Re: City of Austin Urban Forestry Board Recommendations for Locating  
Art in Public Places (AIPP) and Related Structures near Trees

The purpose of this report is to evaluate the health and vigor of the live oak and overall impact of the site changes 2 years prior over the critical root zone. These include the installation of 2 historic buildings infringing on the critical root zone and an art patio work infringing in half the critical root zone.

Grade Was Raised Significantly in 2010 over CRZ of Brush Square Tree

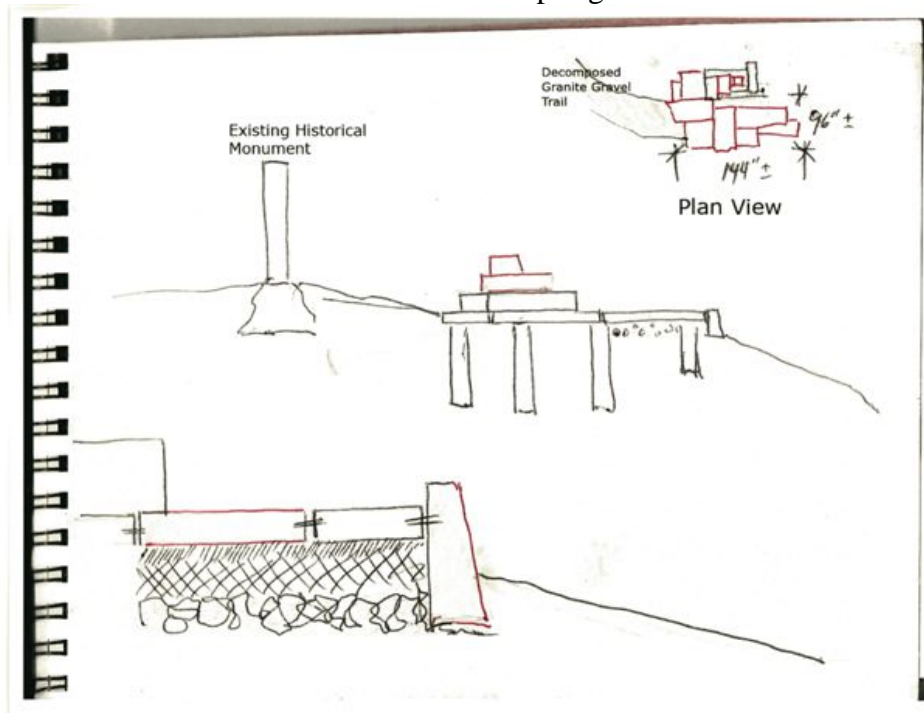
The tree permit that was approved by the City Arborist (attached) for this work required that no cut or fill work be done within the inner one-half of the CRZ. It was intended that the root zone be protected from machinery and trucks to avoid soil compaction. The City Arborist and the Parks and Recreation Department (PARD) recall that the artist, as well as the AIPP-overseeing staff, agreed not to dig within that inside half of the CRZ and that no roots would be cut. However, photographs show that there was significant digging (more than 2 ft. deep) within that area. In addition, the grade was raised by several inches through a significant portion of the CRZ. A large amount of fill was added over the compacted soil, and a significant part of the root zone was covered with impermeable heavy stone; making it very difficult, if not impossible, for the roots to get water. The resulting 1/8-inch spacing between the stones is too small to allow the passage of sufficient water. The decline of this tree demonstrates that these roots

have been affected by all of this work. While the record breaking drought and heat of 2011 affected many trees, the adjacent live oaks are not showing signs of stress, which suggests that the impact of construction, which violated the terms of the tree permit and best practices in tree care, is the primary cause of the leaf yellowing and thinning canopy. Photographs are attached, and you will note that machinery and trucks are shown working within the root zone of the tree.

8 photographs provided by the museum curator showing the construction process. Grade changes are larger than 8 inches through a significant area of the CRZ. The patio coverage is made up of thick limestone slabs tightly juxtaposed with marble slabs. Joints are approximately 1/8 ". No information has been provided regarding root zone impact and mitigation actions during the project other than these photos.

We seek to insure that heritage trees are valued and enjoyed for generations to come. We are therefore recommending that the management and staff charged with administering the AIPP Program take immediate steps to ensure that artwork and related structures not be allowed to be built again within the CRZ of any tree. The UFB requests a briefing from AIPP on any project that involves the CRZ of a protected size tree and larger.

Artist's Sketches for Overlook Construction within CRZ of Heritage Pecan Tree  
In South Lawn of Barton Springs Pool

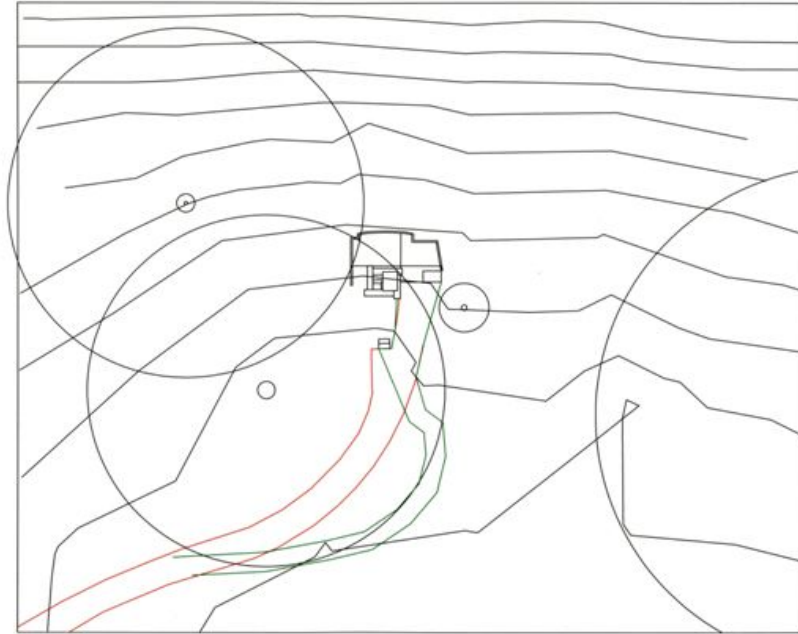
The second case brought to our attention is the heritage pecan on the south lawn of Barton Springs Pool. Artwork was to be installed within the CRZ of this tree in spite of PARD recommending numerous times over several months that it not be done. The installation of an overlook to serve as a base for the artwork required digging within the CRZ of this tree over a large area, but no certified arborists, landscape architects, or engineers were involved in the design. The artist submitted several sketches of the installation (attached). Acting PARD Forestry Manager Angela Hanson explained during a public review meeting that heritage trees are already stressed by drought and does not recommend having artwork installed within their CRZ if that artwork or its installation may cause a permanent impact to the CRZ and she recommends that AIPP projects conform to applicable tree protection rules. It was not until more than 40 concerned citizens protested against this artwork at a public meeting, that it was moved from underneath the tree canopy and located outside the pool fence.
